Access Compliance Report

Public Rights-of-Way

Intersection ID: 3033	Main Street: DEARMON_RD	Cross Street: BENFIELD RD	Location:	N
ADA ID: 5C8AF0BC5FA9	Ramp Type: Perp	Initial Pass/Fail: Fail	Overall Compliance: No	Severity Score: 25

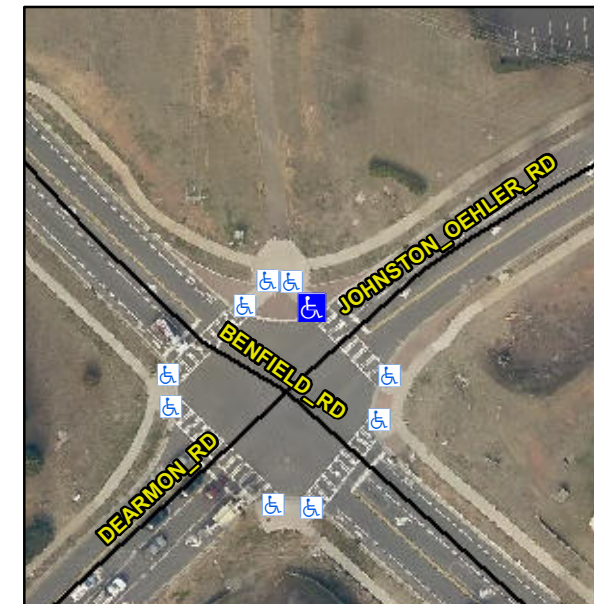
R304.2.2

Compliance	Description	Data	Compliance	Description	Data
N/A	Ramp Length (in)	179.5	No	Ramp Slope (%)	20.0
Yes	Ramp Width (in)	53.0	Yes	Ramp XSlope (%)	0.3
N/A	Flare Type LT	N/A	N/A	Flare Type RT	N/A
N/A	Flare Slope LT (%)	N/A	N/A	Flare Slope RT (%)	N/A
N/A	Flare Traversable LT?	N/A	N/A	Flare Traversable RT?	N/A
N/A	Landing Length (in)	N/A	N/A	DWS Provided?	N/A
N/A	Landing Width (in)	N/A	N/A	DWS Contrast?	N/A
N/A	Landing Slope (%)	N/A	N/A	DWS Length (in)	N/A
N/A	Landing X Slope (%)	N/A	N/A	DWS Full Width?	N/A
N/A	Landing Curb? (Y/N)	N/A	N/A	DWS Offset (in)	N/A
N/A	Shared Landing?	N/A			
N/A	Gutter Ponding?	N/A	N/A	Gutter Slope (%)	N/A
N/A	Gutter Lip Ht (in)	N/A	N/A	Gutter X Slope (%)	N/A
N/A	Painted X Walk1?	No	N/A	Painted X Walk2?	N/A
	X Walk 1 Direction	To SE		X Walk 2 Direction	N/A
N/A	X Walk 1 Width (in)	111.5	N/A	X Walk 2 Width (in)	N/A
	X Walk 1 Slope (%)	1.9		X Walk 2 Slope (%)	N/A
	X Walk 1 X Slope (%)	0.3		X Walk 2 X Slope (%)	N/A

Remove & Replace Entire Ramp.
